DESIGN REVIEW & PRESERVATION BOARD

LOCATION: 1700 I Street

PROPOSAL: Applicant proposes to rehabilitate an essential building on the Official Register

C & K Plaza Office Complex

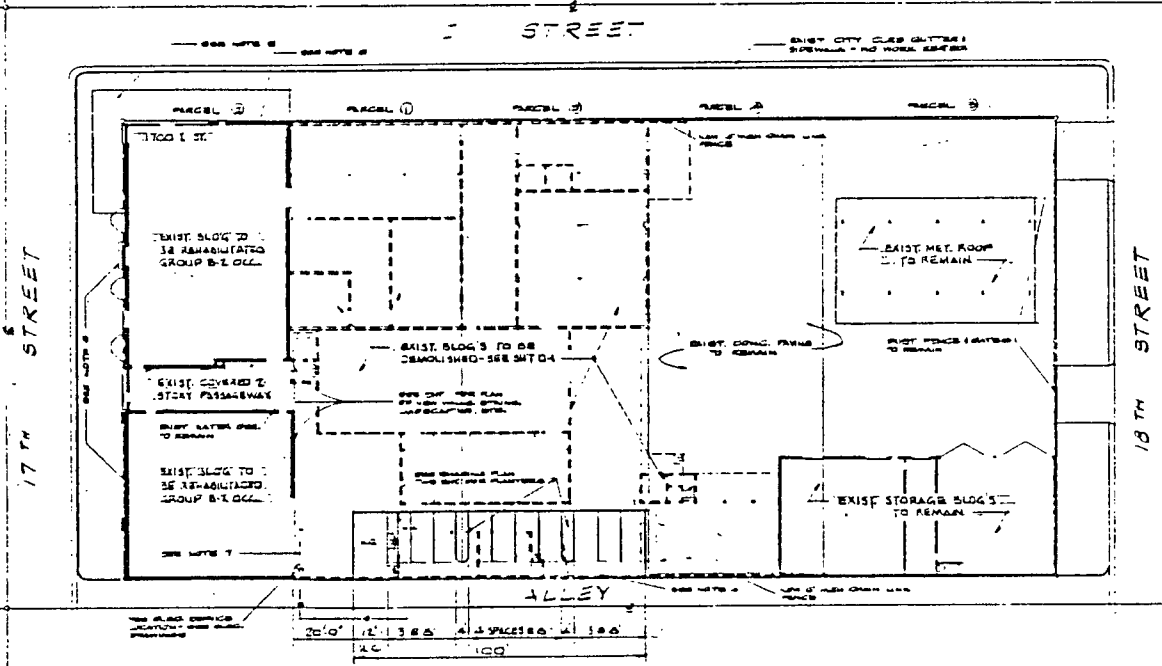
Service areas and placement of air conditioning units need to be called out on the site plan. Any enclosed trash storage area should be placed at the alley next to the parking spaces. As the location of both the trash storage area and the parking spaces may change under Phase II development, staff feels that a wire fence with wood slats or an all wood fence will suffice for the trash storage under Phase I.

All electrical supply units should be relocated from the west side of the structure to the alley elevation, or better yet, underground. The existing utility pole on 17th Street should be removed.

A lot line adjustment will be required from the CPC to include the parking area within the project parcel.

1. Signage to be reviewed and approved by staff.
2. Location of air conditioning units to be reviewed and approved by staff.
3. Trash storage area to be provided.
4. New entry opening in west elevation to be single arch. More detailed drawings showing brickwork of arch to be reviewed and approved by staff.
5. More complete drawings of stairways on east elevation to be reviewed and approved by staff.
6. New sidewalk and curbing to be installed where needed.
7. All electric supply service to be removed from west elevation. New service to be from alley or underground.
8. Utility pole on 17th Street near alley to be removed.
9. Final landscaping, shading and irrigation plans to be reviewed and approved by staff.
10. All zoning ordinance requirements are to be met.

EAST ELEVATION

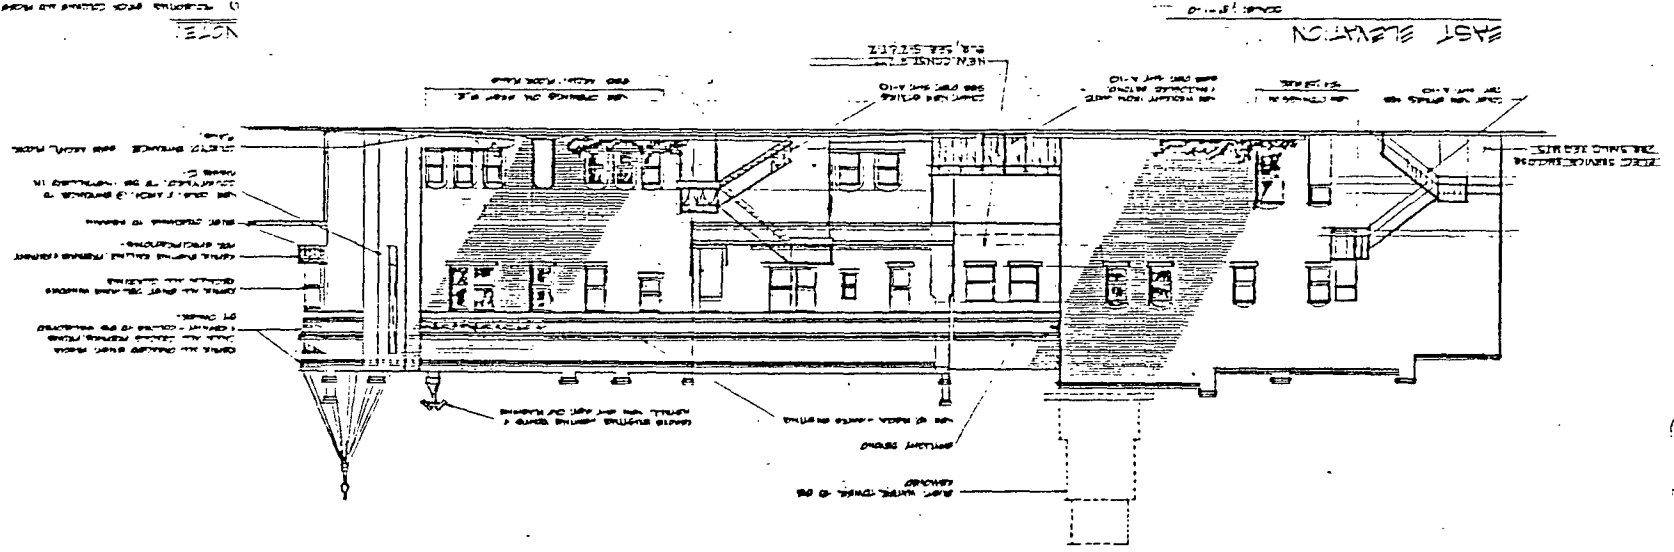
window openings at the first floor level near I Street, and two new door and window openings towards the rear, near the alley. Two new stairways will be built, one at the center and one at the rear of the east elevation. All new wrought iron work will match the existing railing found at the 2nd floor on the I street facade. Sheet metal heating vent caps will be removed from the top of some chimneys. The rehabilitation of this building will be Phase I of a two-phase project. Phase II will be the construction of a new office building on the vacant part of the block to the east.

The two new stairways at the east side of the building should have the same type of railing design - one that replicates the second floor front railing will work well. The stairway structure itself should be in wood to match the rest of the wood detailing of the building.

WEST ELEVATION

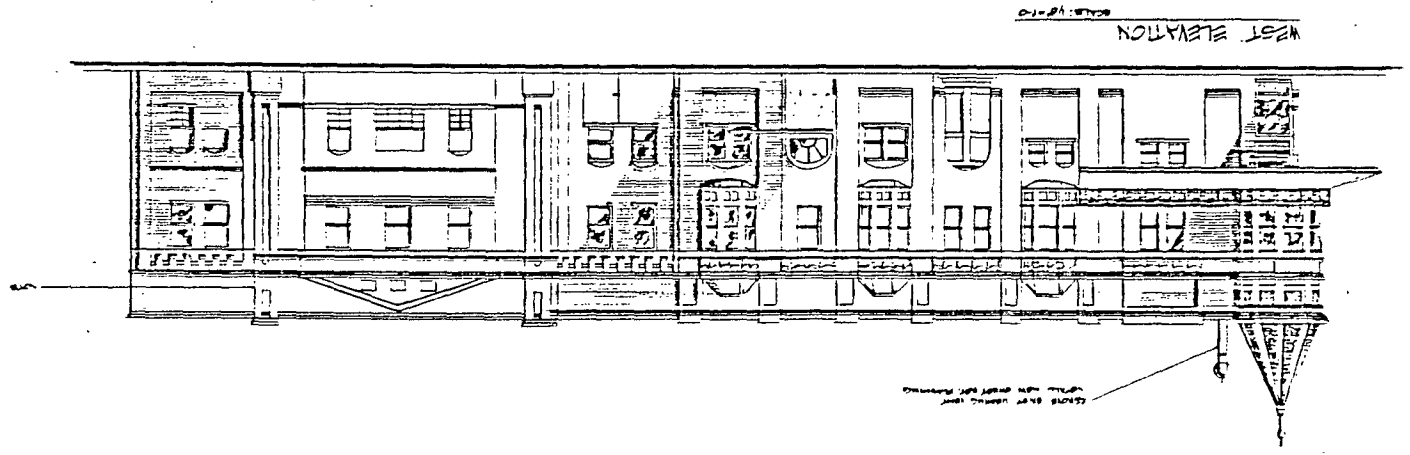
Staff feels that the addition of new openings are appropriate in that they meet the needs of the new use of the building, and yet retain a feel of time and place important to the older style of the structure. Staff would support the proposed new single arched entry way in place of the alternate double arched opening. This treatment of a new opening into a covered passageway is in harmony with the other openings on the older northern portion of the structure. It will also allow for a pleasing entry into this two-story high passageway.
